Access Compliance Report

Public Rights-of-Way

(Curb Ramps)

Intersection ID: 49931	Main Street: WOBURN_RD	Cross Street: ASHBOURNE_HALL_RD	Location: SW
ADA ID: F80E1CB3560B	Ramp Type: Perp	Initial Pass/Fail: Fail	Overall Compliance: No
Severity Score: 25			
Codes/Mitigation Info/Possible Solution		Field Measurements/Component Compliance

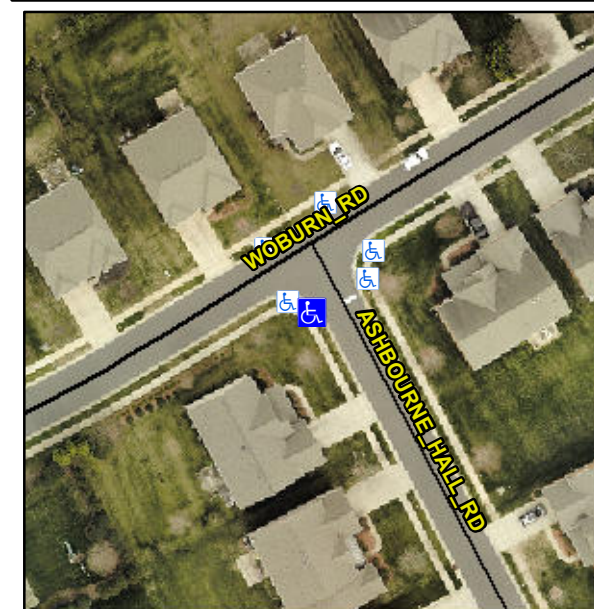
Not Found, R304.2.2, R304.5.3

Compliance	Description	Data	Compliance	Description	Data
N/A	Ramp Length (in)	47.0	No	Ramp Slope (%)	9.0
Yes	Ramp Width (in)	48.0	No	Ramp XSlope (%)	5.3
N/A	Flare Type LT	N/A	N/A	Flare Type RT	N/A
N/A	Flare Slope LT (%)	N/A	N/A	Flare Slope RT (%)	N/A
N/A	Flare Traversable LT?	N/A	N/A	Flare Traversable RT?	N/A
N/A	Landing Length (in)	N/A	N/A	DWS Provided?	N/A
N/A	Landing Width (in)	N/A	N/A	DWS Contrast?	N/A
N/A	Landing Slope (%)	N/A	N/A	DWS Length (in)	N/A
N/A	Landing X Slope (%)	N/A	N/A	DWS Full Width?	N/A
N/A	Landing Curb? (Y/N)	N/A	N/A	DWS Offset (in)	N/A
N/A	Shared Landing?	N/A			
N/A	Gutter Ponding?	N/A	N/A	Gutter Slope (%)	N/A
N/A	Gutter Lip Ht (in)	N/A	N/A	Gutter X Slope (%)	N/A
N/A	Painted X Walk1?	No	N/A	Painted X Walk2?	N/A
	X Walk 1 Direction	To NE		X Walk 2 Direction	N/A
N/A	X Walk 1 Width (in)	N/A	N/A	X Walk 2 Width (in)	N/A
	X Walk 1 Slope (%)	1.8		X Walk 2 Slope (%)	N/A
	X Walk 1 X Slope (%)	1.6		X Walk 2 X Slope (%)	N/A

Remove & Replace Entire Ramp.
